Service Manual

Personal Facsimile / Facsimile with Digital Answering System

Supplement-2

Subject : Addition of New type Thermal Head

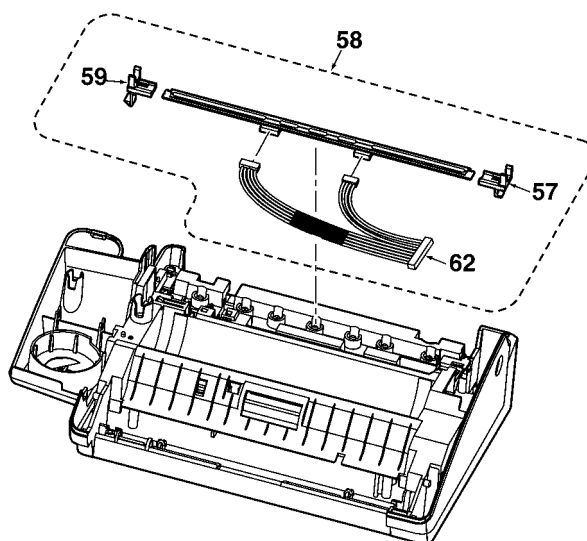
Ref. No.	Part No.		Part Name & Description	Pcs/ Set	Remarks	Notes	Time of Change (Suffix)
	Original (Old)	New					
UPPER CABINET SECTION							
57	-----	PNDE1004Z1	ARM, HEAD HOLDER RIGHT	1	*a	5 Y	-----
58	L1CC00000063	PNVE1006Z	PRINTER UNITS, THERMAL HEAD KIT	1	*a	1 W	-----
59	-----	PNDE1003Z1	ARM, HEAD HOLDER LEFT	1	*a	5 Y	-----
62	-----	PNJS14100Z	CONNECTOR	1	*a	5 Y	-----

Note:
The supply for Thermal Head is changed from single to KIT.
Both Head Holders and Connector is added a new type.
Refer to next page for details.

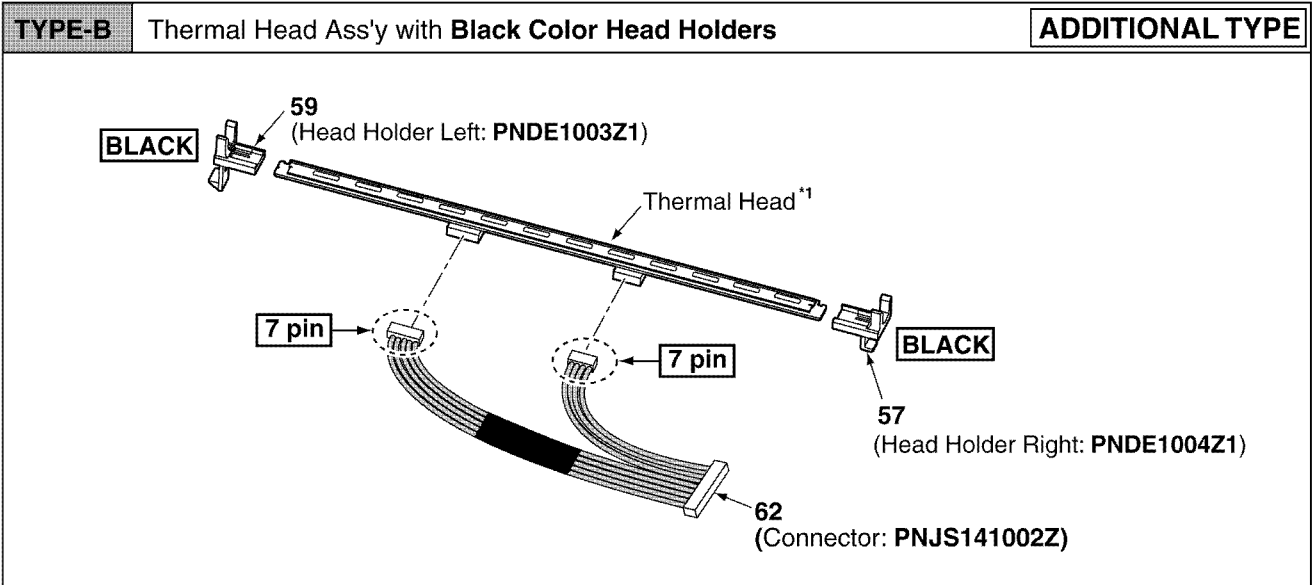
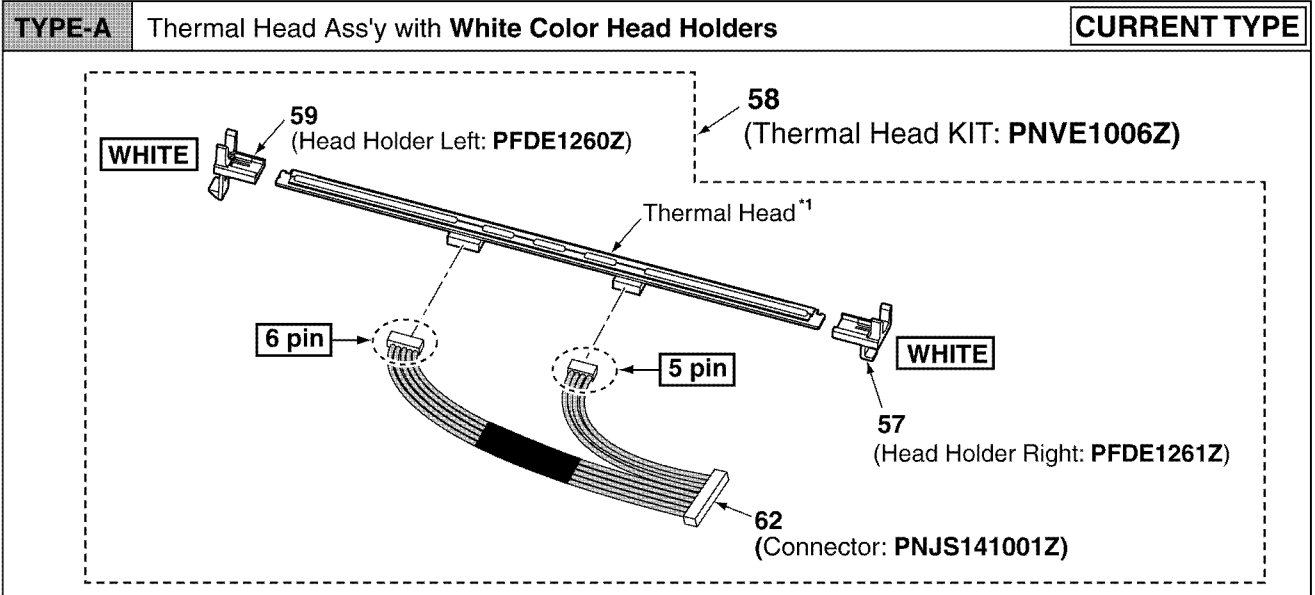
Due to production reason, we supply Thermal Head KIT in place of a Thermal Head (single).

The components of Thermal Head KIT is TYPE-A. (See below.)

If the Head Holders (Ref no. 57 and 59) in the unit is Black color, Thermal Head is Type-B. So, please replace all the parts supplied as a Thermal Head Kit.

In the case of White color, please replace only Thermal Head. There is no need to replace both Head Holders and Connector.

When replacing the Thermal Head, order the part no. of the KIT, **PNVE1006Z**.

When you replace the both Head Holders or Connector, please check by below figure, then order the same part no. as you should replace.
